TOWN OF MILFORD, NH  
OFFICE OF COMMUNITY DEVELOPMENT

**Date:** August 10, 2022  
**To:** Planning Board  
**From:** Lincoln Daley, Community Development Director  
**Subject:** SP2022-05 30 Wilton Road LLC for the property located at Tax Map 6, Lot 14, 30 Wilton Road. Public Hearing for a Conditional Use Permit/Major Site Plan Application to construct 3 story, 40 foot tall, 13,950 square foot (41,850 square foot gross floor area) self-storage facility and associated, parking, site and drainage improvements in the Integrated Commercial Industrial zoning District and West Elm Overlay. (*Continued from 7/21/22*)

PROJECT:  
**STORAGE SENSE - MILFORD WEST**

ELEVATIONS

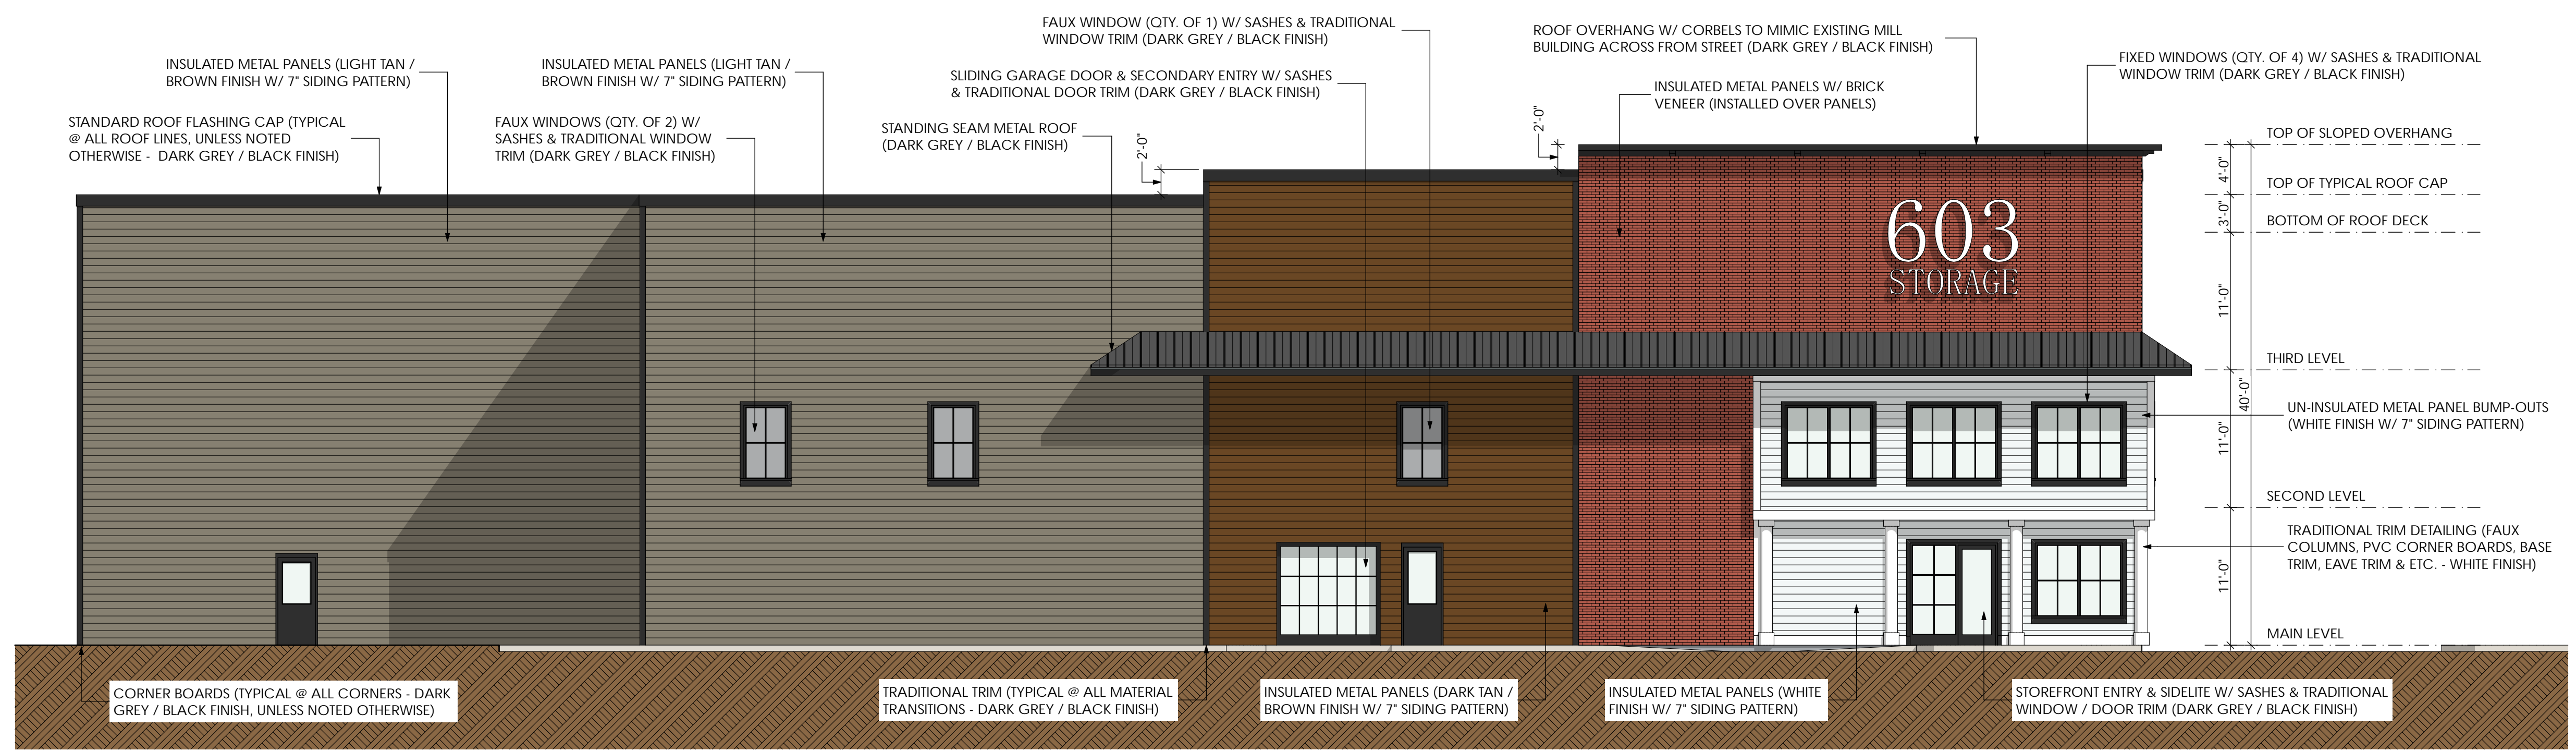
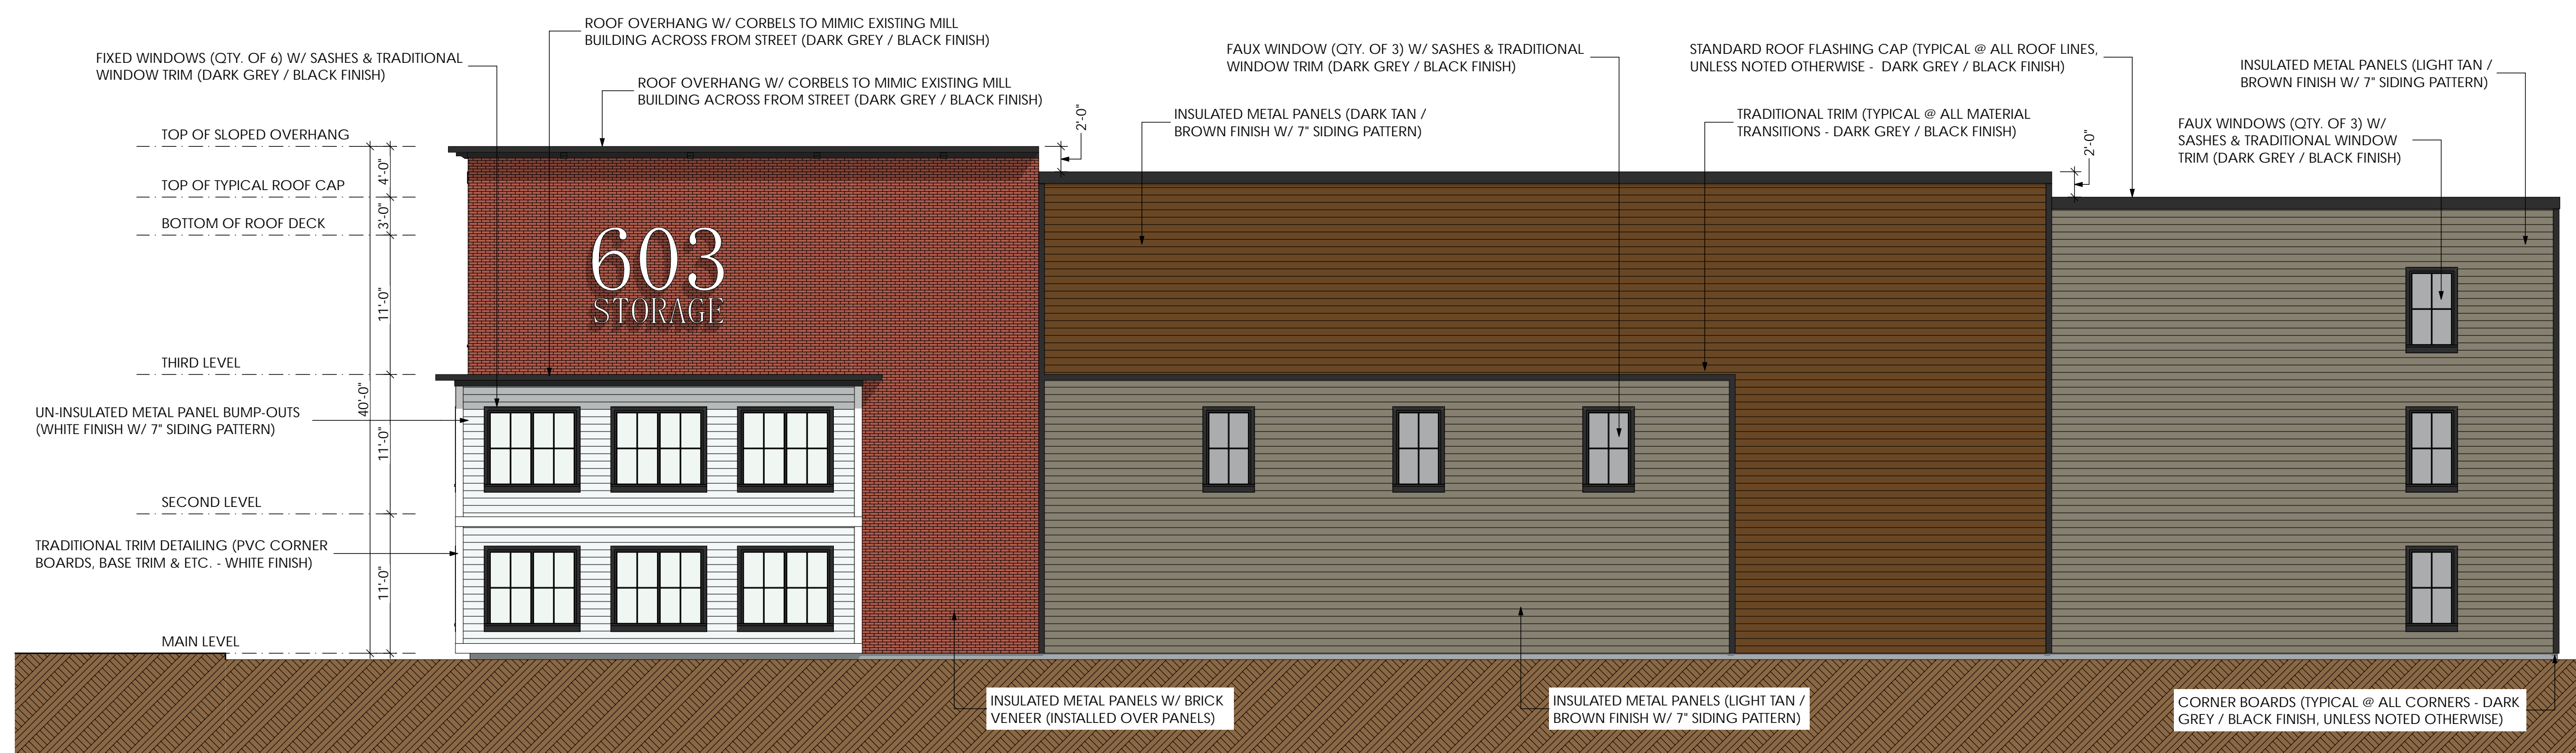
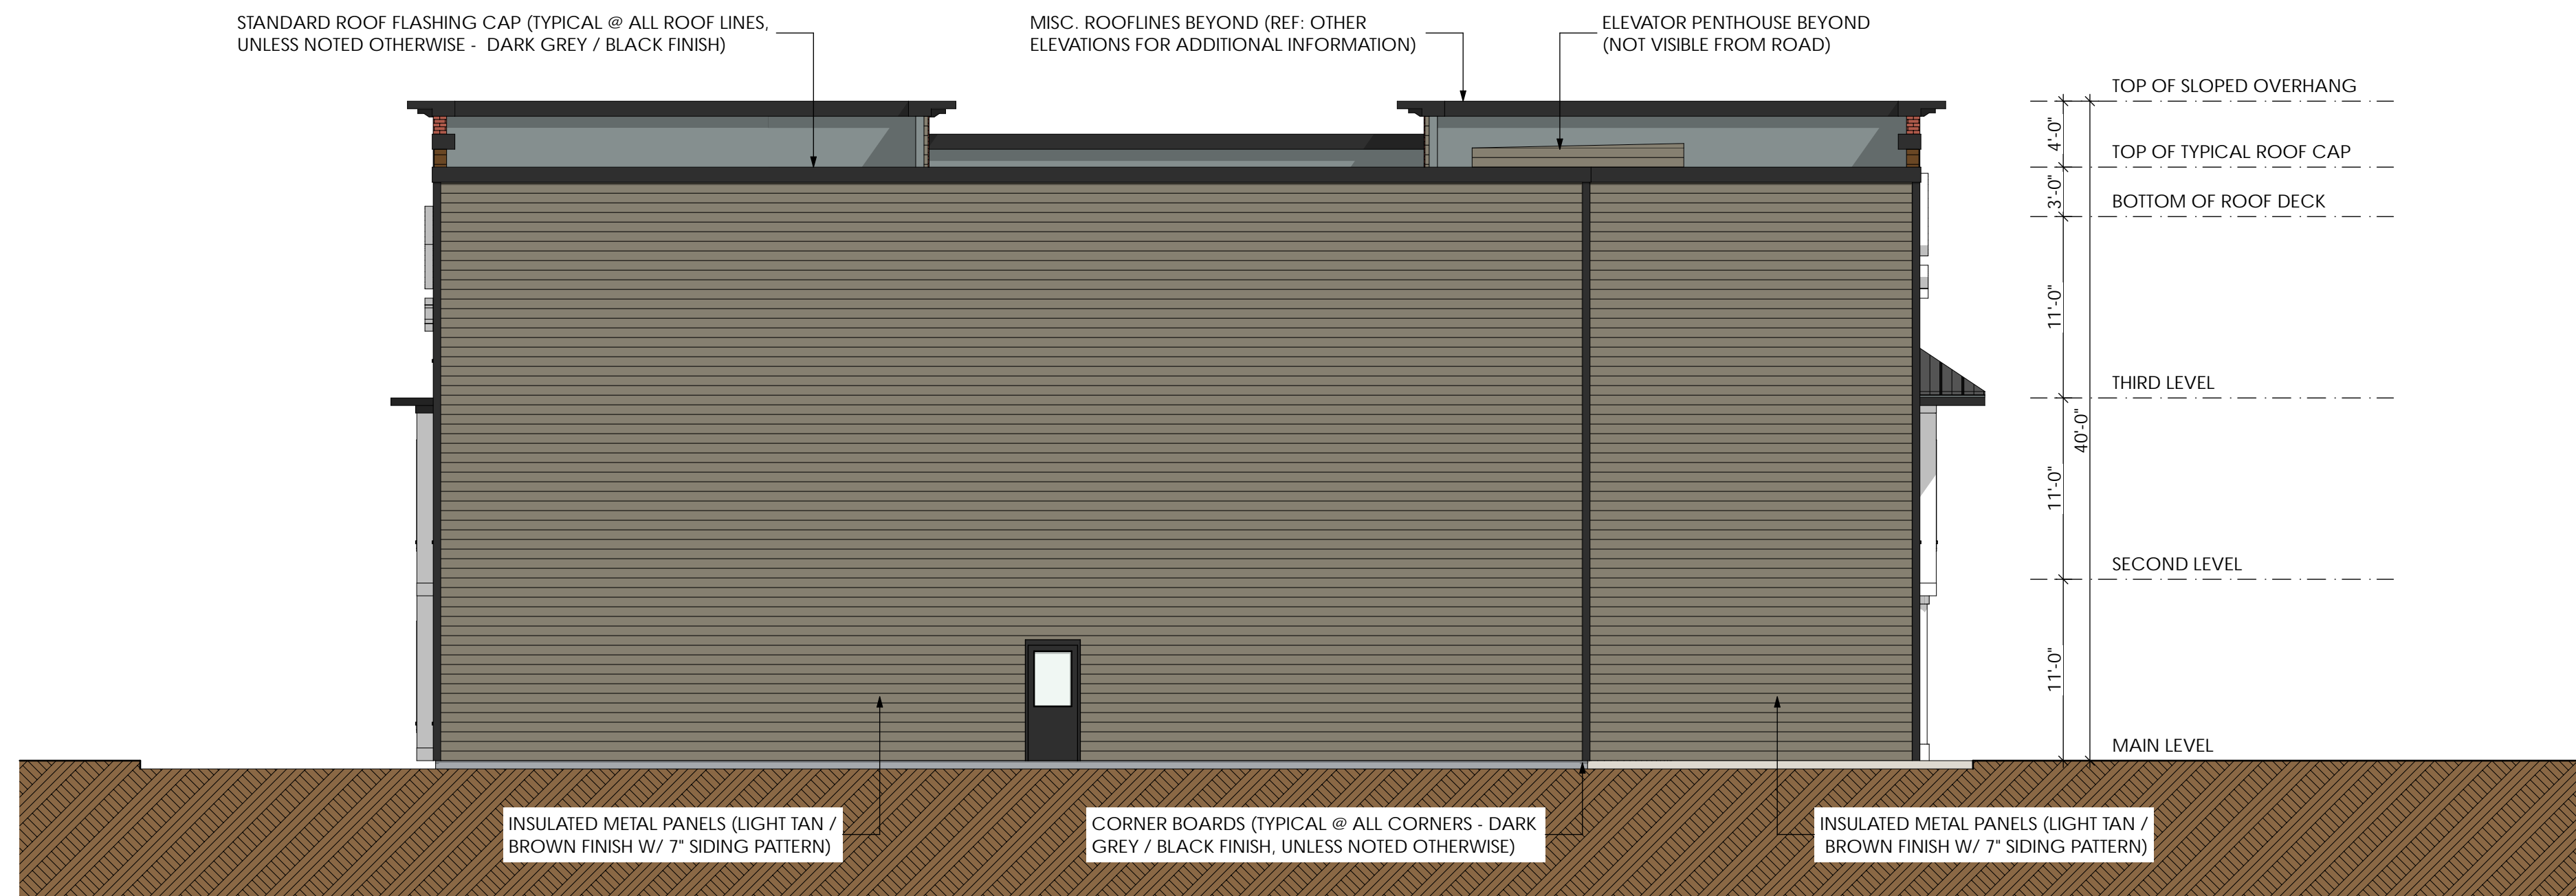
14. General Comment – Zoning Ordinance, Section 6.07.6.E.2 Building Massing, Form, Height. Pursuant to Section 6.07.06.E.2, to enhance the character of new development and the corridor, the building scale should be reduced introducing small- scaled architectural features, creating an irregular footprint and variations in roof forms and height of roof elements.

Please explain how the side elevations of the building meet these design standards and what alternatives were considered. The applicant submitted revised building elevations for Board consideration.

15. General Comment – Zoning Ordinance, Section 6.07.6.E.3 Architectural Features and Materials. Pursuant to Section 6.07.06.E.3, long expanses of repetitive architectural elements and flat unarticulated wall surfaces shall be avoided. Please explain how the side elevations of the building meet this requirement and what alternatives were considered. Please modify the plan in compliance with this section or request a waiver from said section. *The applicant submitted revised building elevations for Board consideration.*

16. General Comment – Zoning Ordinance, Section 6.07.6.E.8 Windows. Consideration should be given to adding windows or other architectural features to the side elevations to break up the walls. *The applicant submitted revised building elevations for Board consideration which include additional windows along the sides of the building.*

18. General Comments – Building Design and Elevations
- a. Roof Form and Materials – Section 6.07.E.7 of the Zoning Ordinance and the Development Regulations, Section 6.04.3 state that rooflines shall be characteristically sloped and articulated with architectural features such as dormers, chimneys, gables, cupolas, etc. Further, flat roofs are strongly discouraged unless the Planning Board finds that a proposal can provide appropriate visual appeal. In addition, rooflines shall not run in continuous planes and shall be broken into appropriately scaled masses. Please explain how the front and side roof lines of building meet these requirements. Further, please discuss what alternative building designs were considered for the location, corridor, and in context with Milford’s architectural heritage.

***See 8/9/22 Response Letter. The Board will need to determine if the building design complies the referenced section of the Ordinance. If no, then the Board should provide additional guidance and recommendations.***

***See 8/9/22 Response Letter. The Board will need to determine if the building design complies the referenced section of the Ordinance. If no, then the Board should provide additional guidance and recommendations.***

***See 8/9/22 Response Letter. The Board will need to determine if the building design complies the referenced section of the Ordinance. If no, then the Board should provide additional guidance and recommendations.***

- The applicant submitted revised building elevations for Board consideration.*
- See 8/9/22 Response Letter. The Board will need to determine if the building design complies the referenced section of the Ordinance. If no, then the Board should provide additional guidance and recommendations.***
